CHATHAM COUNTY PURCHASING & CONTRACTING DEPARTMENT

ADDENDUM NO. 2 TO 21-0097-4

FOR: WILLOW LAKES DRAINAGE IMPROVEMENTS

TYPICAL TRENCH DETAIL
FOR HDPE CORRUGATED PIPE

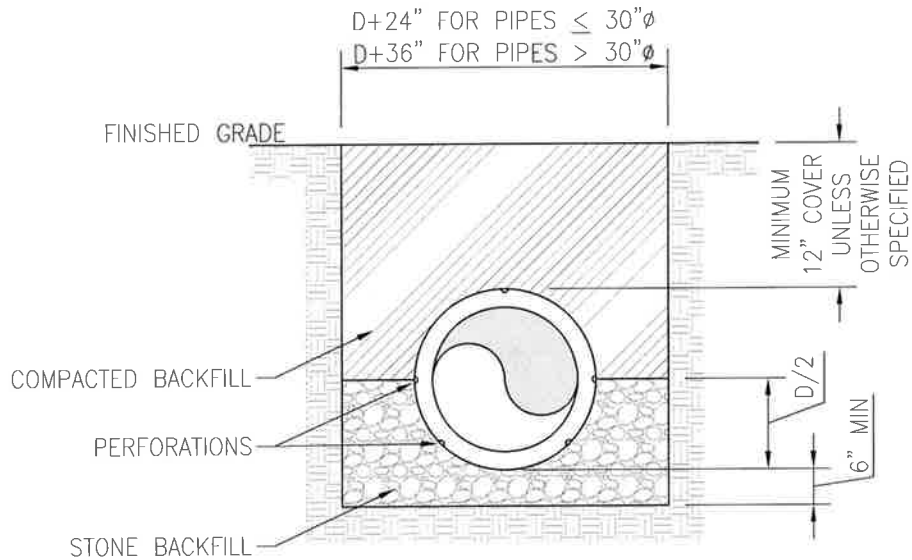
1. See attached Responses to Questions Received (1 page)
2. Replace current Bid Sheet with the attached *revised* Bid Sheet. (1 page)
3. See attached *Typical Trench Detail for HDPE pipe model.* (1 page)

Alternate 1					
1.	Substitute 48" HDPE for 48" RCP. Price includes all excavation, trenching, pipe, joints, filter fabric, anchoring, backfill, compaction, televising and all incidental labor and material necessary to complete the construction of pipe.	2476	LF

1. COMPACT SUBGRADE TO 100% STD COMPACTION FOR TRAFFIC AREAS AND 95% STD COMPACTION FOR NON-TRAFFIC AREAS.
2. COMPACTED BACKFILL SHALL BE 100% STD COMPACTION FOR TRAFFIC AREAS AND 95% STD COMPACTION FOR NON-TRAFFIC AREAS.
3. STONE SHALL BE #57 STONE.
4. BACKFILLING SHALL BE ACCOMPLISHED WITH LAYERS NOT EXCEEDING 6" LIFTS TO 12" ABOVE THE PIPE THEN LAYERS NOT EXCEEDING 8" LIFTS TO FINISHED GRADE.
5. COST OF STONE BACKFILL TO BE INCLUDED IN PRICE BID FOR PIPE.
6. CONTRACTOR SHALL INSTALL FOUR PERFORATIONS NO SMALLER THAN $\frac{1}{2}$ " IN DIAMETER AROUND THE BOTTOM OF THE PIPE AND ONE PERFORATION ON THE TOP OF THE PIPE ON EVERY OTHER CORRUGATION ALONG THE ENTIRE LENGTH OF ALL PIPES TO ENSURE THE PIPES DO NOT FLOAT.
7. IN LIEU OF PERFORATIONS, CONTRACTOR MAY USE TIE DOWN STRAPS WITH SCREW ANCHORS LOCATED AT THE MIDPOINT OF EACH PIPE SECTION AND ON EACH SIDE OF THE PIPE JOINTS.
